Access Compliance Report

Public Rights-of-Way

Intersection ID: 10035532	Main Street: REA_RD	Cross Street: N/A	Location: NW
ADA ID: 36A6EDA76651	Ramp Type: Perp	Initial Pass/Fail: Fail	Overall Compliance: No
		Severity Score: 25

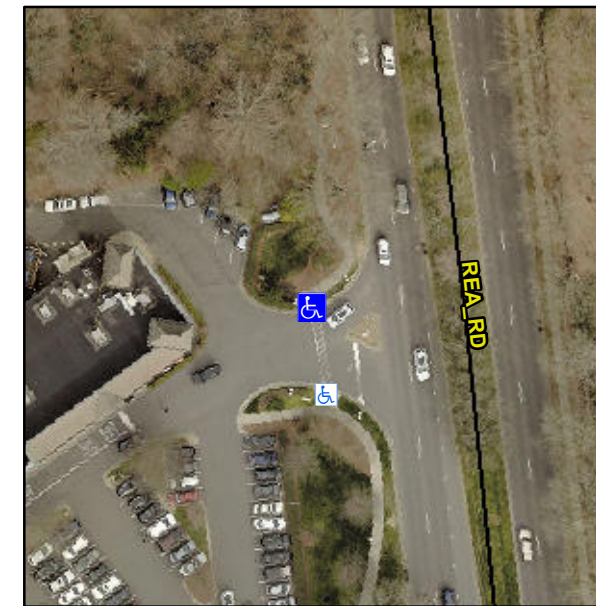
Not Found, R304.5.3

Compliance	Description	Data	Compliance	Description	Data
N/A	Ramp Length (in)	51.0	Yes	Ramp Slope (%)	8.0
Yes	Ramp Width (in)	48.0	No	Ramp XSlope (%)	11.1
N/A	Flare Type LT	N/A	N/A	Flare Type RT	N/A
N/A	Flare Slope LT (%)	N/A	N/A	Flare Slope RT (%)	N/A
N/A	Flare Traversable LT?	N/A	N/A	Flare Traversable RT?	N/A
N/A	Landing Length (in)	N/A	N/A	DWS Provided?	N/A
N/A	Landing Width (in)	N/A	N/A	DWS Contrast?	N/A
N/A	Landing Slope (%)	N/A	N/A	DWS Length (in)	N/A
N/A	Landing X Slope (%)	N/A	N/A	DWS Full Width?	N/A
N/A	Landing Curb? (Y/N)	N/A	N/A	DWS Offset (in)	N/A
N/A	Shared Landing?	N/A			
N/A	Gutter Ponding?	N/A	N/A	Gutter Slope (%)	N/A
N/A	Gutter Lip Ht (in)	N/A	N/A	Gutter X Slope (%)	N/A
N/A	Painted X Walk1?	Yes	N/A	Painted X Walk2?	N/A
	X Walk 1 Direction	To S		X Walk 2 Direction	N/A
N/A	X Walk 1 Width (in)	52.0	N/A	X Walk 2 Width (in)	N/A
	X Walk 1 Slope (%)	2.9		X Walk 2 Slope (%)	N/A
	X Walk 1 X Slope (%)	8.5		X Walk 2 X Slope (%)	N/A

Remove & Replace Entire Ramp.
